AGENDA
PLANNING COMMISSION REGULAR MEETING
CITY OF FARMINGTON HILLS
OCTOBER 15, 2026 at 7:30 P.M.
FARMINGTON HILLS CITY HALL – CITY COUNCIL CHAMBER
31555 W. ELEVEN MILE ROAD, FARMINGTON HILLS, MICHIGAN 48336
Cable TV: Spectrum – Channel 203; AT&T – Channel 99
YouTube Channel: <https://www.youtube.com/user/FHChannel8>
www.fhgov.com (248) 871-2540

A. [SITE PLAN APPROVAL 61-9-2026](#)

LOCATION:	30775 W. Twelve Mile Rd.
PARCEL I.D.:	22-23-14-101-015
PROPOSAL:	Renovations to an existing car wash building exterior façade within the B-3, General Business District.
ACTION REQUESTED:	Site Plan Approval
APPLICANT:	Jax Kar Wash (Todd Gesund)
OWNER:	BMW Kar Wash dba Jax Kar Wash

DATE: October 9, 2026
TO: Planning Commission
FROM: Diane Mulville-Friel, City Planner
SUBJECT: Preliminary Site Plan Approval SP 61-9-2026 – Jax Kar Wash - 30775 W. 12 Mile Rd – Parcel ID #22-23-14-101-015
PLAN DATE: September 9, 2026
ZONING: B-3 General Business District

SHEET
A.1

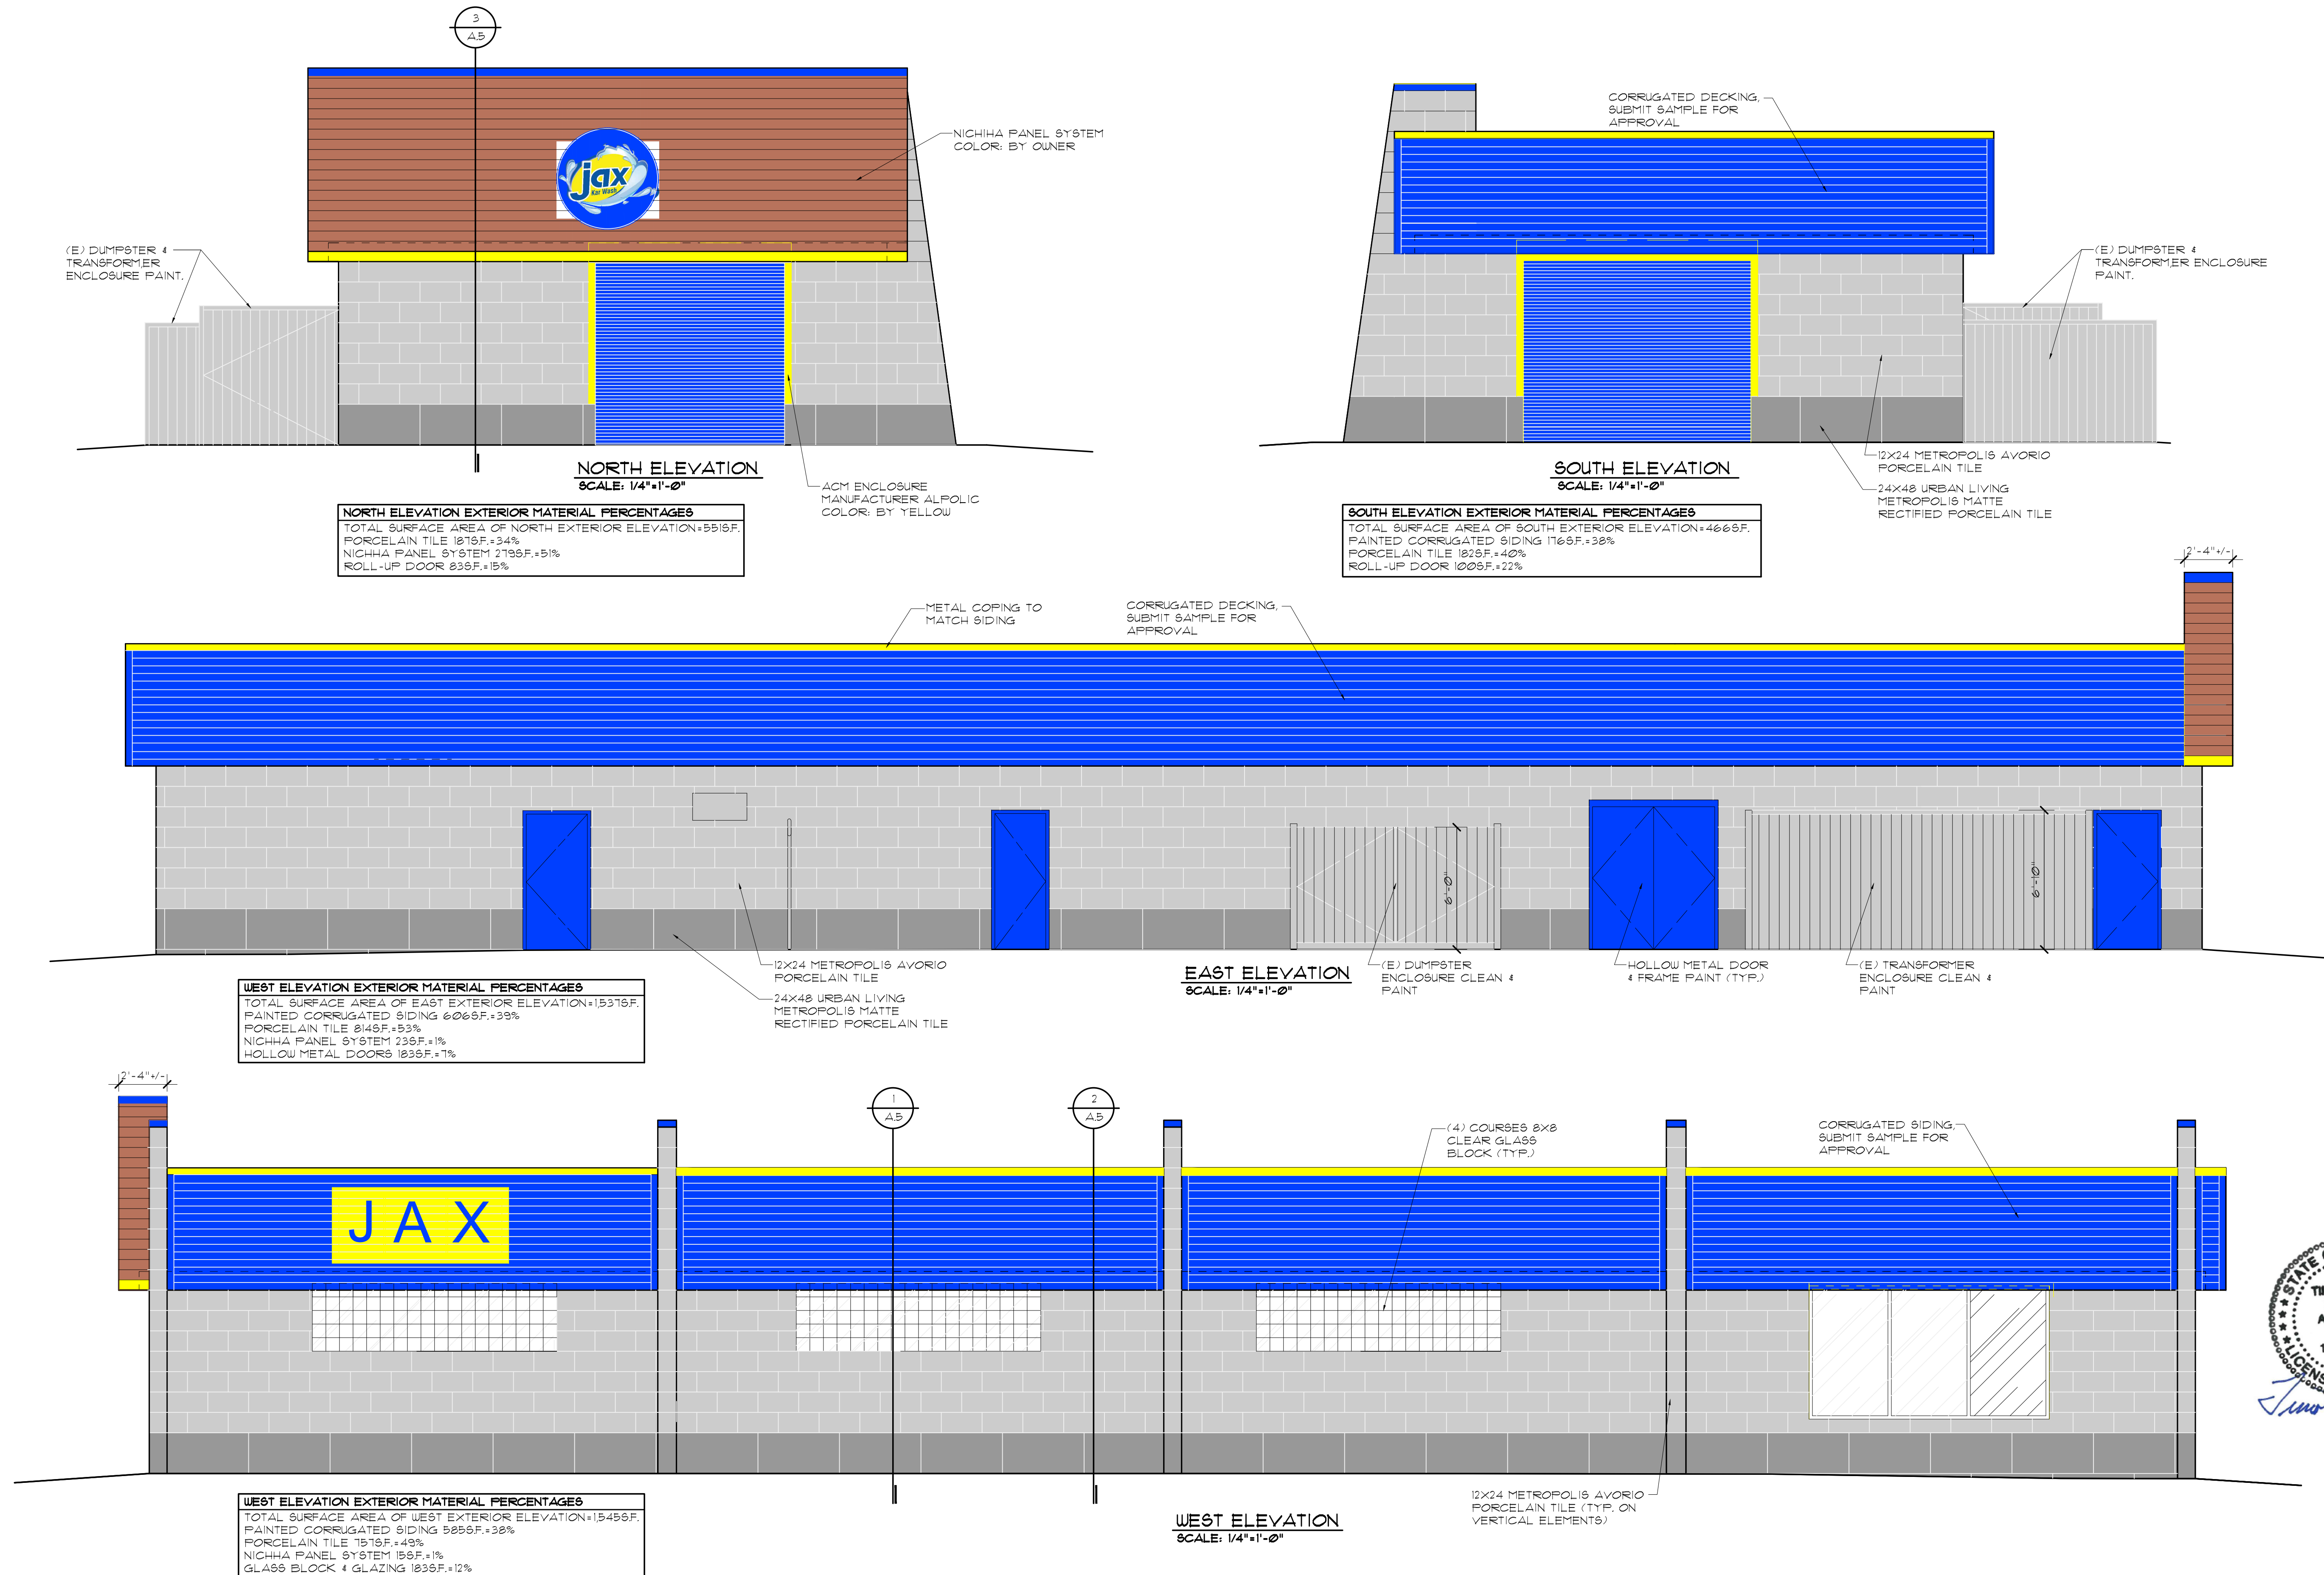
- 1) *The note about speakers and televisions on Sheet A.1 must be removed from the plan. If such equipment is proposed, the applicant must provide additional information about the equipment quantity, location(s), and intended use.*

- 2) *Update the cover sheet (A.1) to add an aerial photograph with parcel boundaries next to the location map.*
- 3) *The applicant must remove sheet A.6; the site plan layout is inaccurate and unnecessary as no site changes are proposed. Additional site information may be required if any site improvements are proposed.*

- 4) *The applicant must confirm the legal description is correct and include on the cover sheet (A.1)..*
- 5) *Any proposed exterior lighting modifications will require a separate review and approval.*

SHEET
A.6

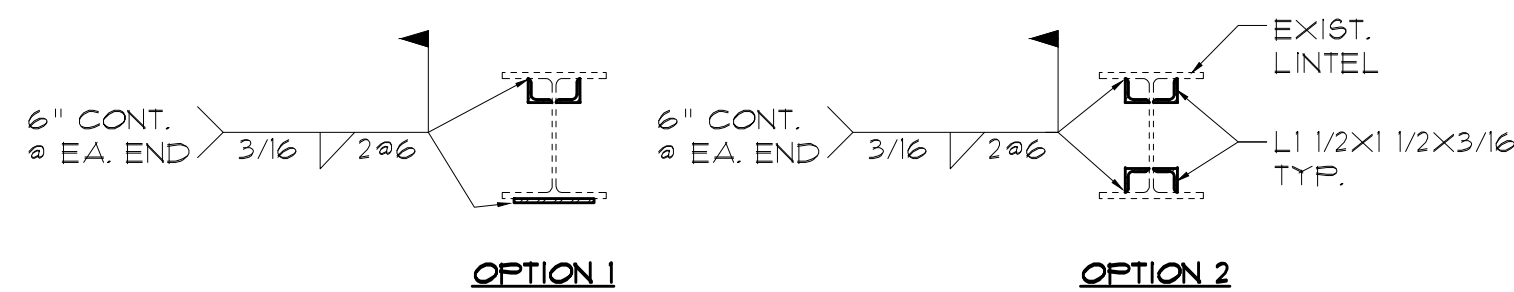
The site layout plan, property boundaries, and legal description included on sheet A.6 are not accurate and do not match the property records available in the City's BS&A and online GIS records. The applicant must remove sheet A.6 and update cover sheet (A.1) to include corrected legal description and include an aerial photograph with parcel boundaries next to the location map.
